INDEX OF STRUCTURAL DRAWINGS

STATE OF HAWAII DEPARTMENT OF TRANSPORTATION HIGHWAYS DIVISION. INDEX OF STRUCTURAL DRAWINGS. INTERSTATE ROUTE H-1 AND H-201 DESTINATION SIGN UPGRADE/REPLACEMENT, PHASE 3B. FAP NO. NH-0300(205). Scale: None Date: Oct. 2023 SHEET No. S1.1 OF 5 SHEETS

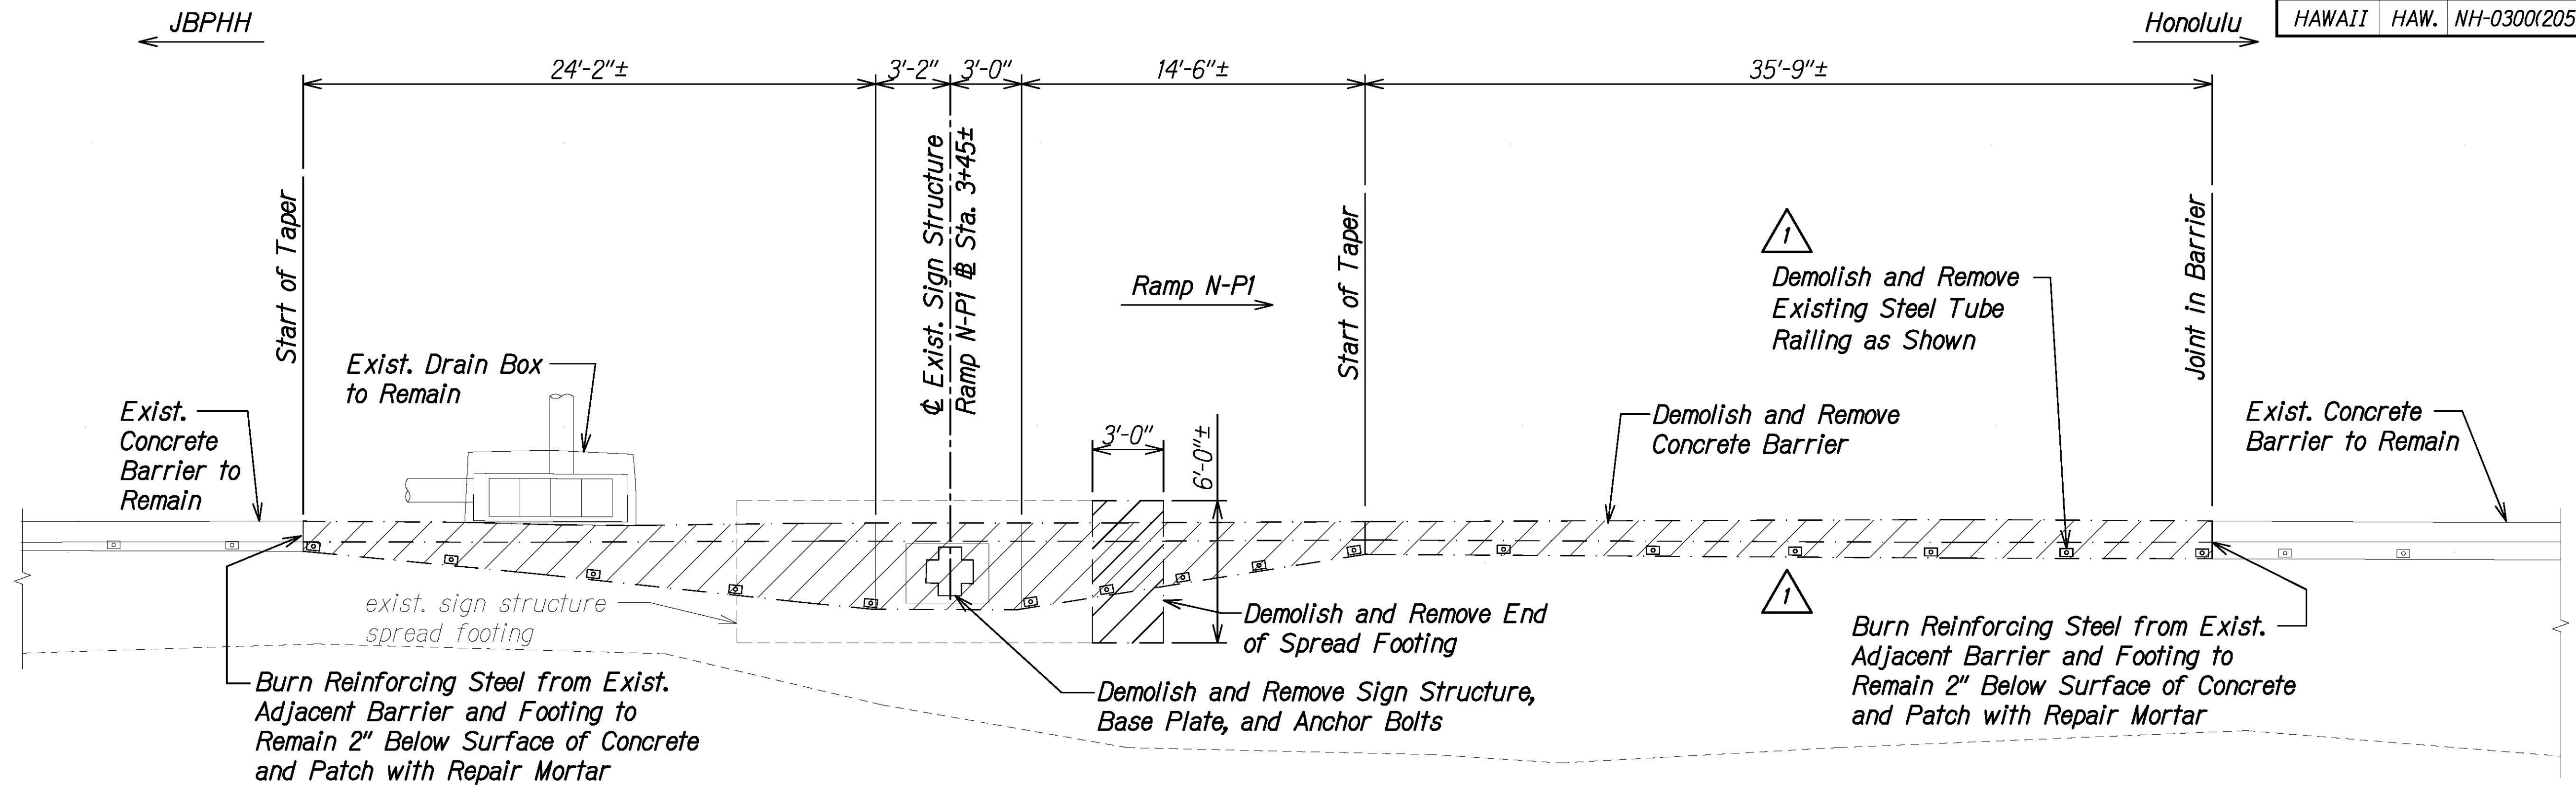
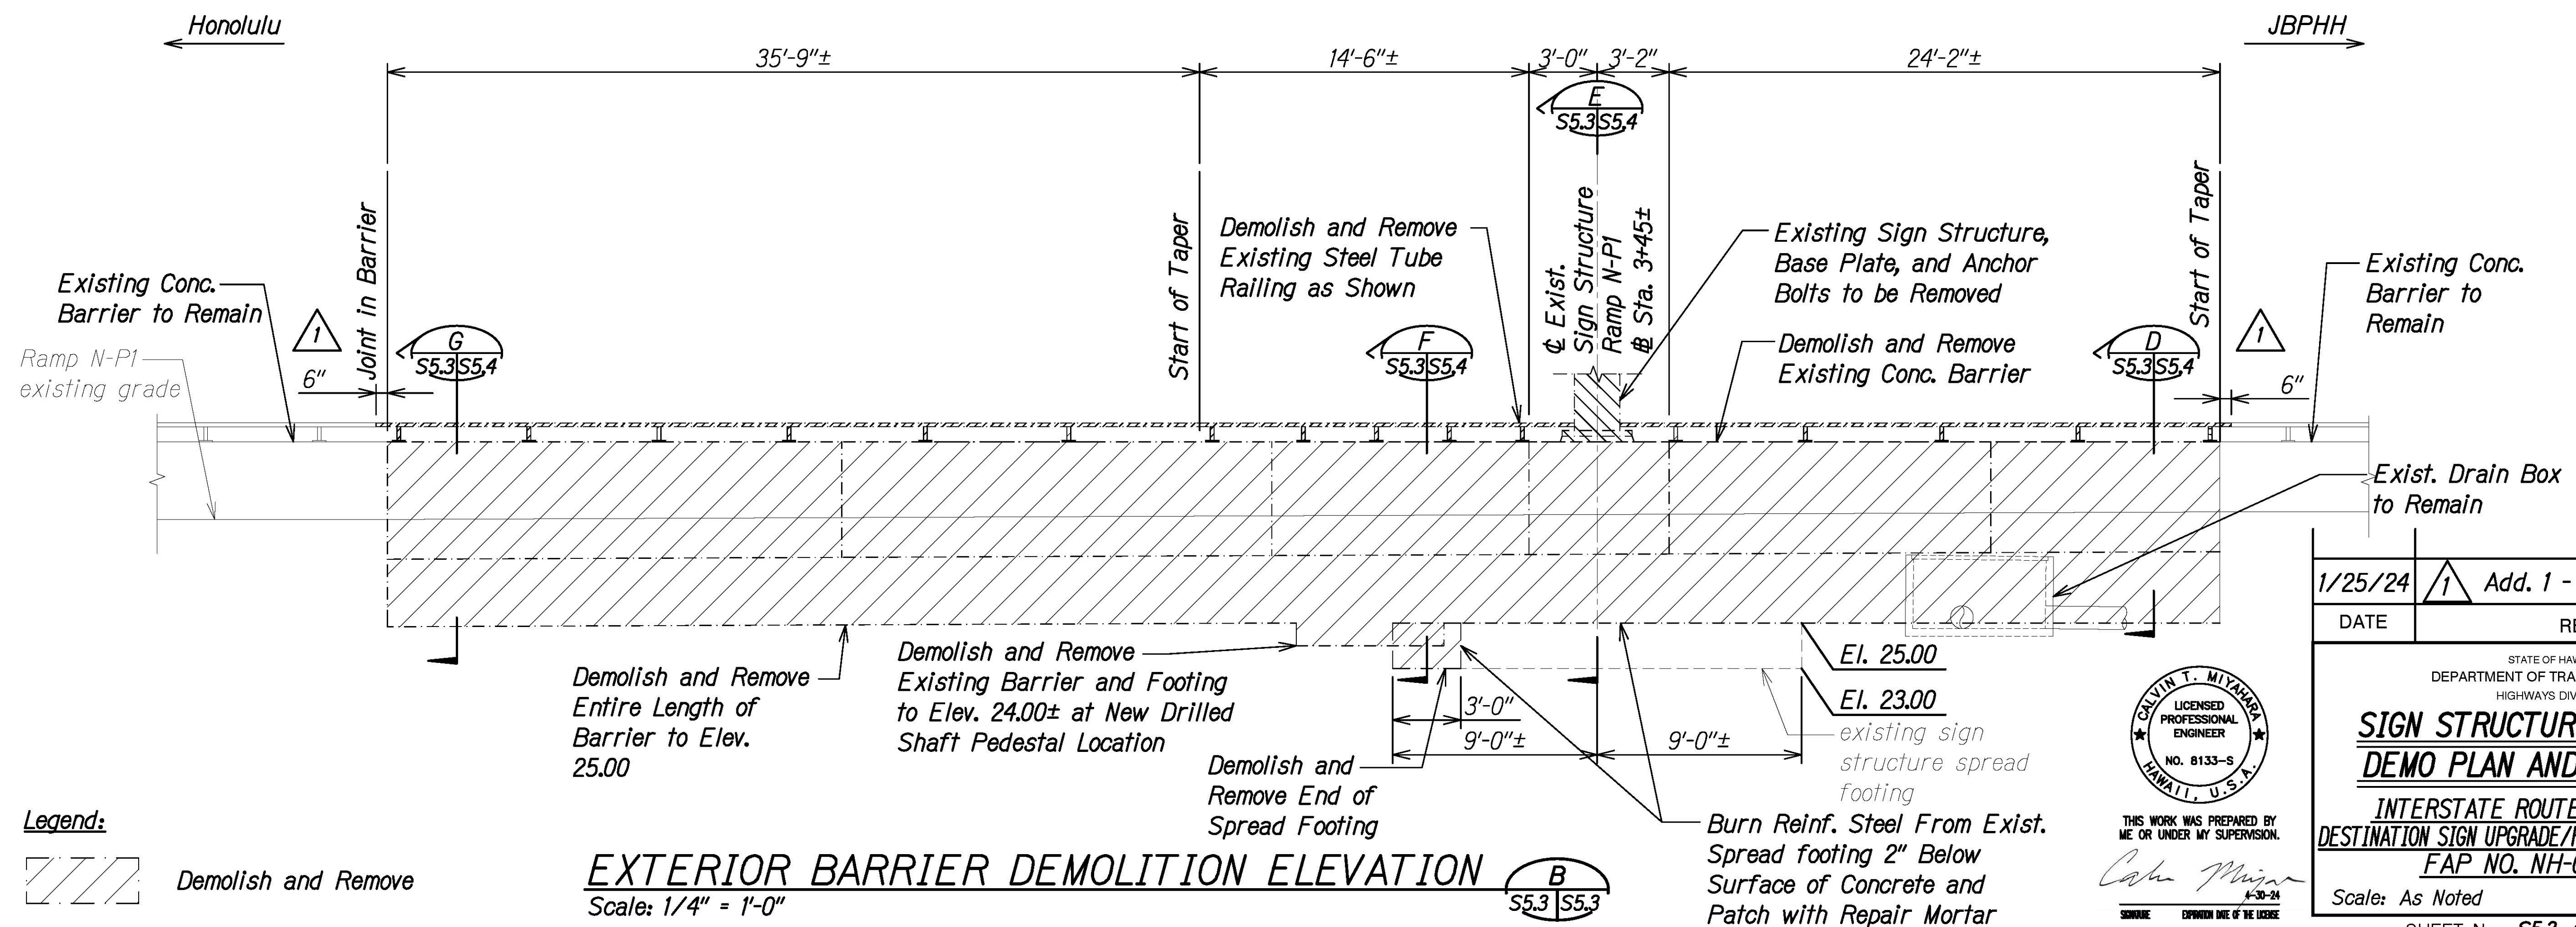
DATE	1/25/24	REVISION	1 Add. 1 - Revised Details
STATE OF HAWAII DEPARTMENT OF TRANSPORTATION HIGHWAYS DIVISION			
SIGN STRUCTURE HIEBR-260 DEMO PLAN AND ELEVATION			
INTERSTATE ROUTE H-1 AND H-201 DESTINATION SIGN UPGRADE/REPLACEMENT, PHASE 3B FAP NO. NH-0300(205)			
Scale:	As Noted	Date:	Oct. 2023
SHEET No. S5.3 OF 11 SHEETS

SIGN STRUCTURE HIEBR-260
EXTERIOR BARRIER PLAN AND ELEVATION

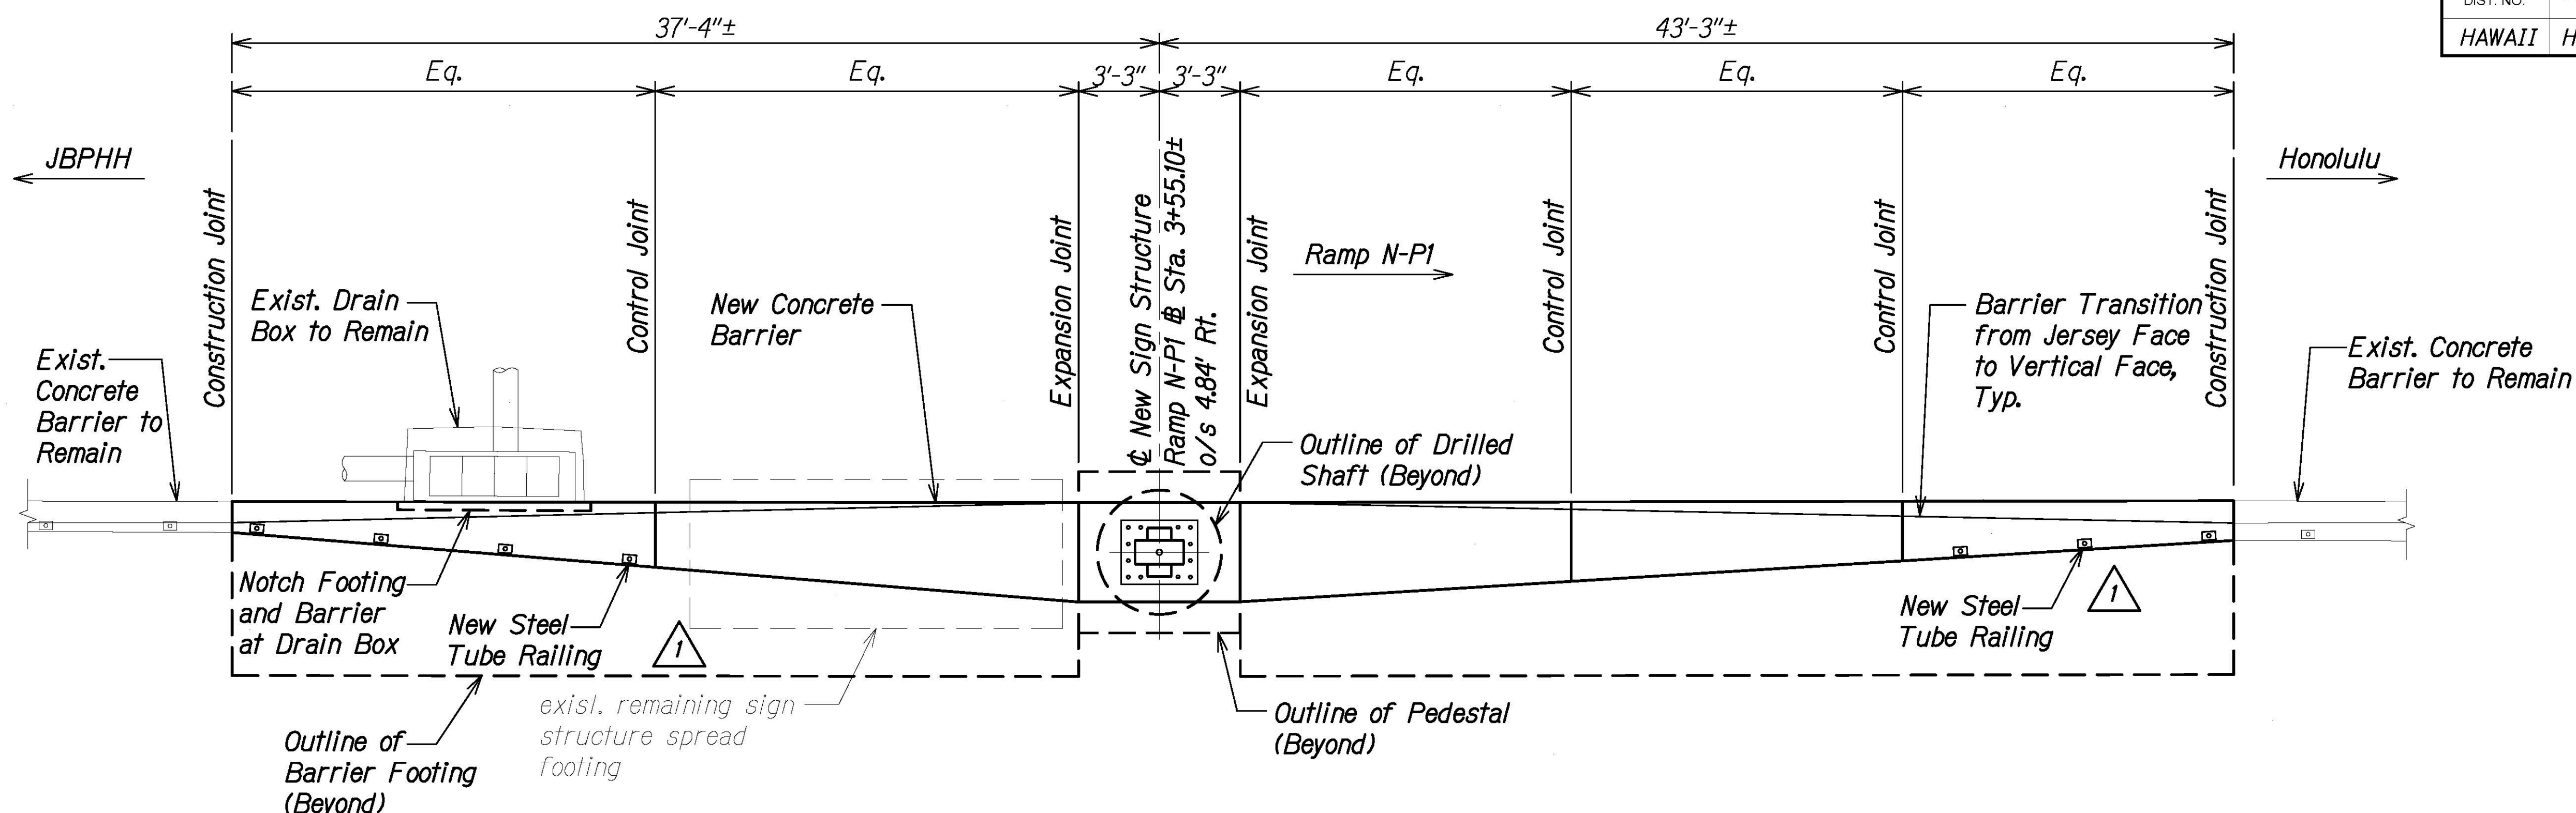
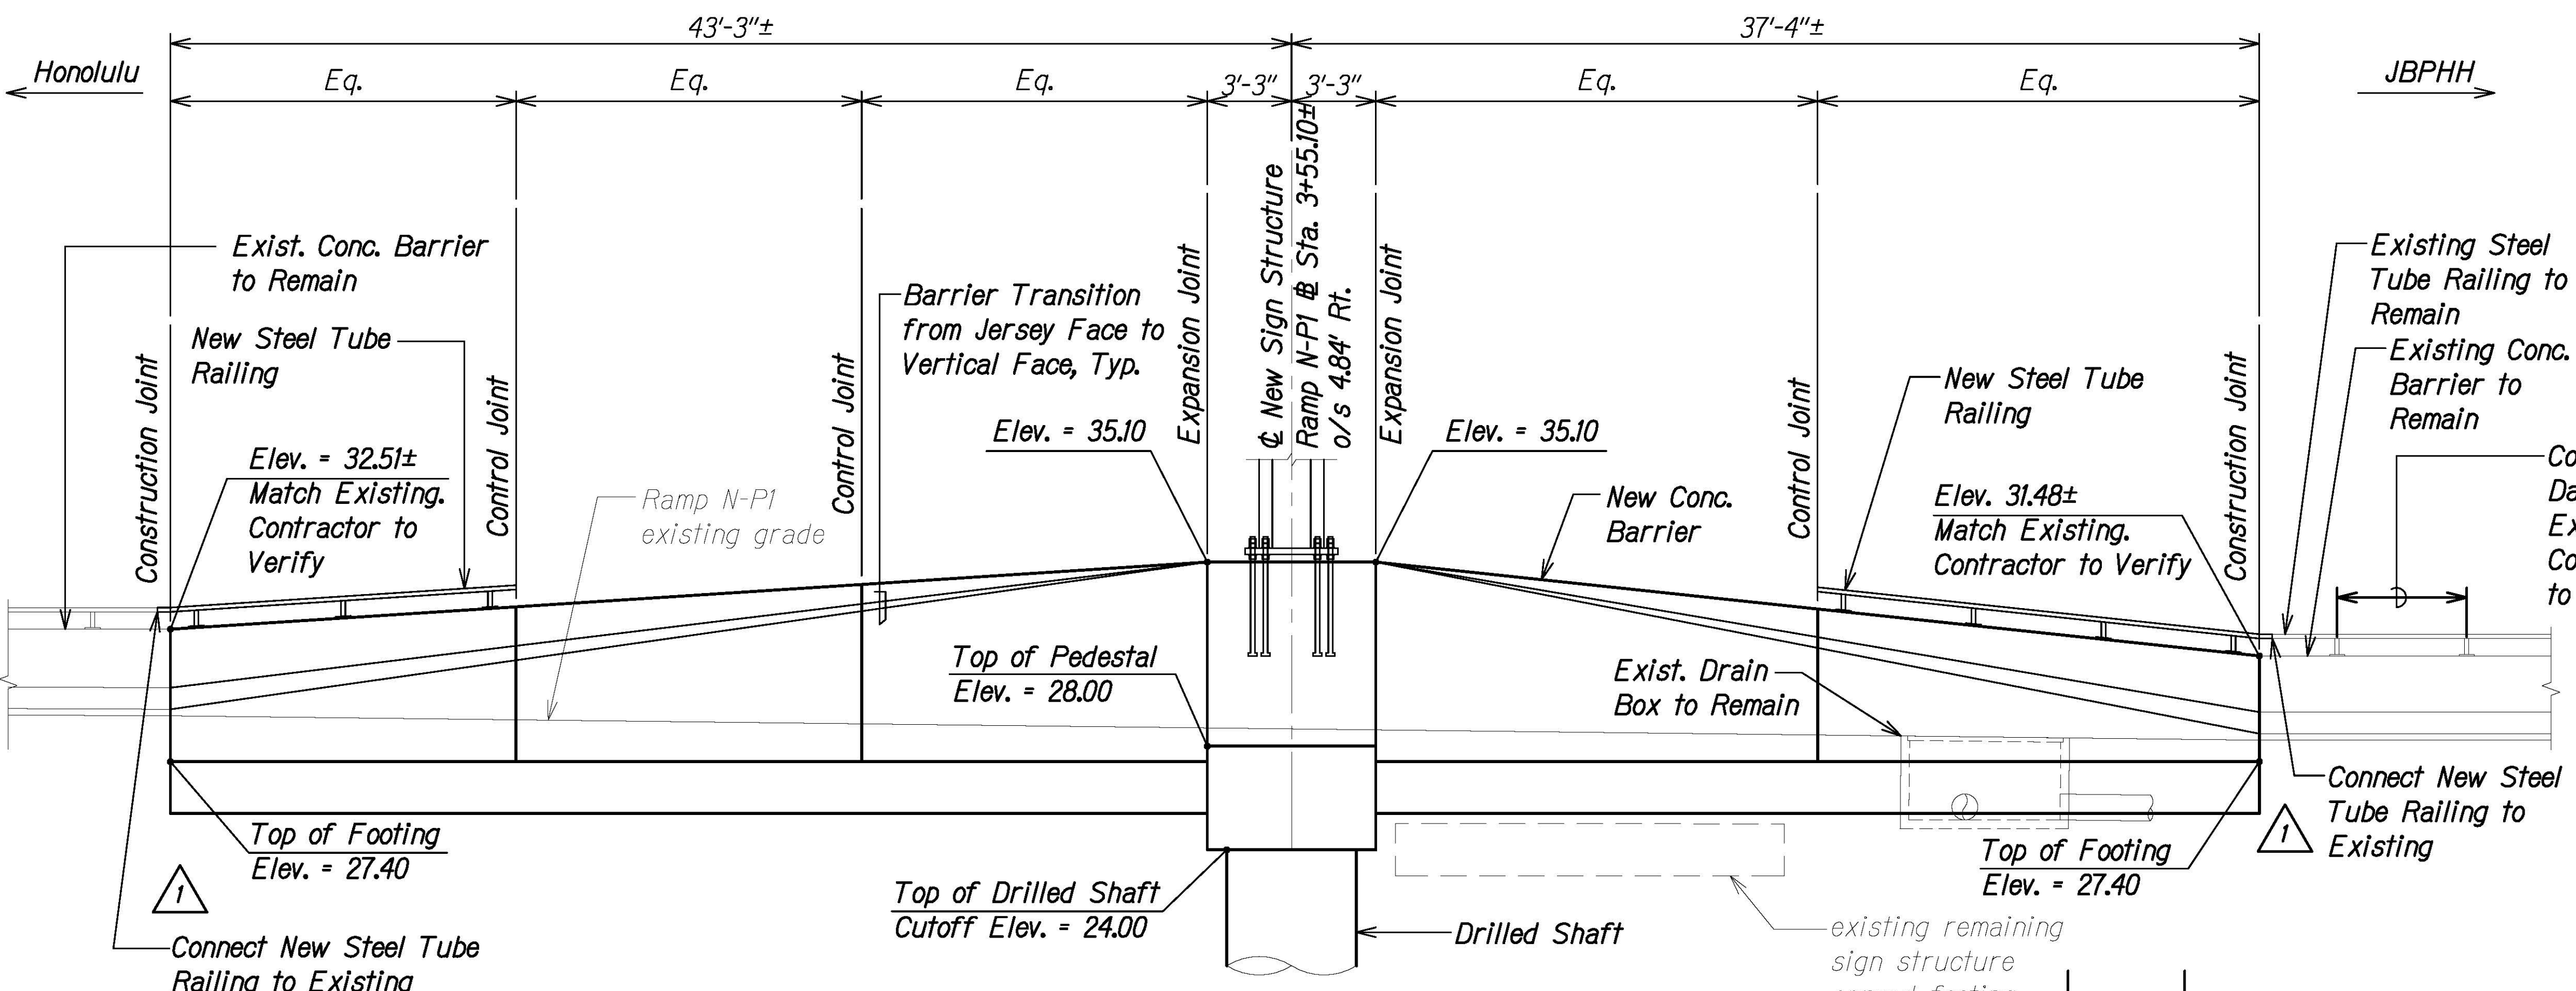
DATE	REVISION
1/25/24	1 Add. 1 - Revised Details
